RBG-45950

May 14, 2002

SUBJECT: River Bend Station, Unit 1
Docket No. 50-458
License Amendment Request
LAR 2002-17, River Bend Nuclear Station Proposed Amendment of
Facility Operating License to Remove Operating Mode Restrictions for
Performing Emergency Diesel Generator Testing

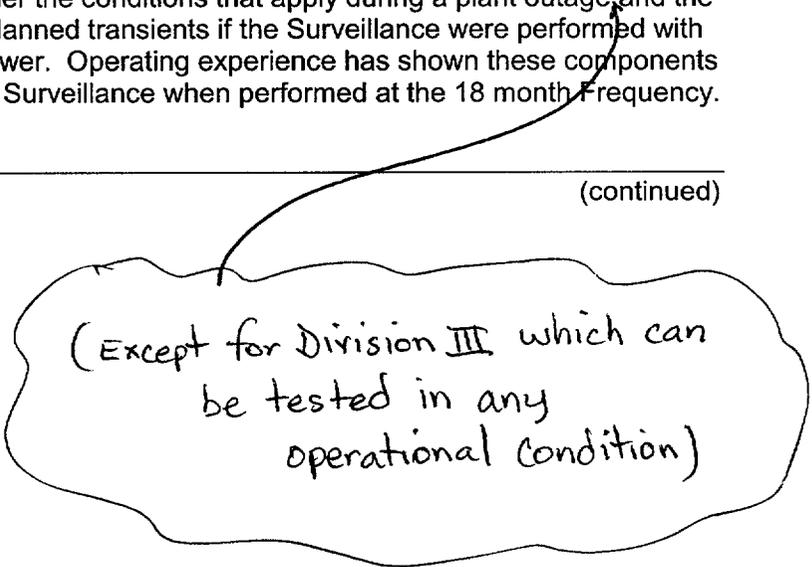
(Except for Division III which can be tested in any operational condition)

SR 3.8.1.12 (continued)

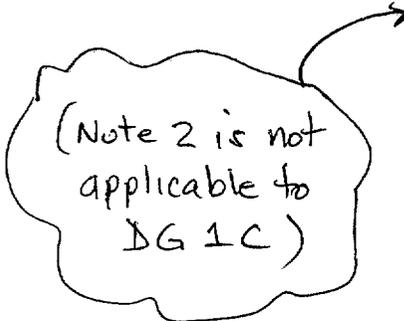
(Note 2 is not applicable to DG 1C)
